**METROPOLITAN GOVERNMENT OF NASHVILLE AND DAVIDSON COUNTY**

**STAFF RECOMMENDATION**  
**1721 5<sup>th</sup> Avenue North**  
**May 21, 2014**

**Application:** Violation  
**District:** Salemtown Neighborhood Conservation Zoning Overlay  
**Council District:** 19  
**Map and Parcel Number:** 08108046200  
**Applicant:** Gail Wales, owner  
**Project Lead:** Melissa Baldock, melissa.baldock@nashville.gov

| <p><b>Description of Project:</b> Applicant requests to retain a siding that does not meet the design guidelines and is different than what was permitted.</p> <p><b>Recommendation Summary:</b> Staff recommends disapproval of the lap reveal finding that it does not meet section III.D.b of the <i>Salemtown Neighborhood Conservation Zoning Overlay: Handbook &amp; Design Guidelines</i>.</p> | <p><b>Attachments</b><br/><b>A:</b> Photographs<br/><b>B:</b> Permit for new construction<br/><b>C:</b> Emails from applicant</p> |

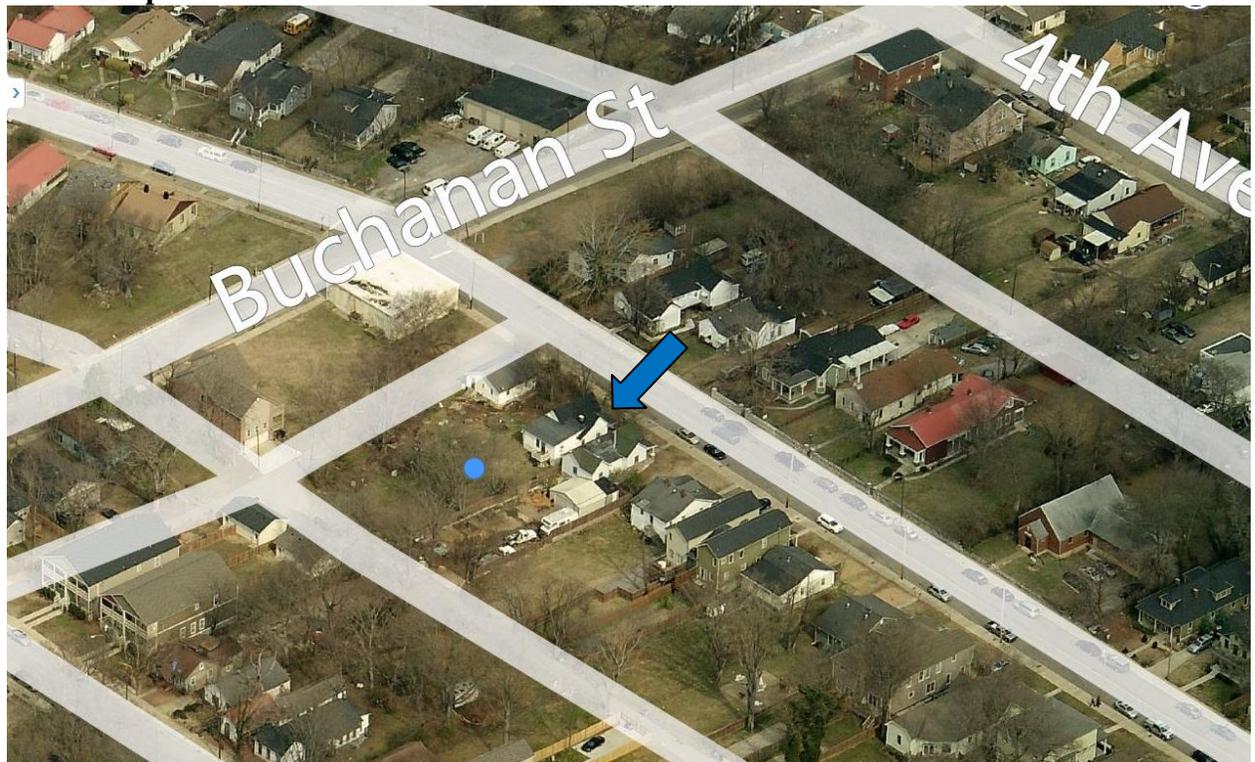
Materials. The primary cladding for the structure was permitted by the MHZC to be fiber cement siding with a five inch (5") reveal, meeting section III.D.b of the design guidelines. A siding with a seven inch reveal was installed instead. The applicant now requests to retain the siding. Staff recommends disapproval since the reveal of the siding does not meet design guidelines III.D.b which states that "lap siding should be smooth and not stamped or embossed and have a maximum of a five-inch (5") reveal" and it is different than what was noted on both the text portion and drawings of the permit.

The applicant has submitted several examples of wider siding in the neighborhood. (Please see attached emails.) The examples are not of historic siding.

**Recommendation Summary:** Staff recommends disapproval of the lap reveal finding that it does not meet section III.D.b of the *Salemtown Neighborhood Conservation Zoning Overlay: Handbook & Design Guidelines*.
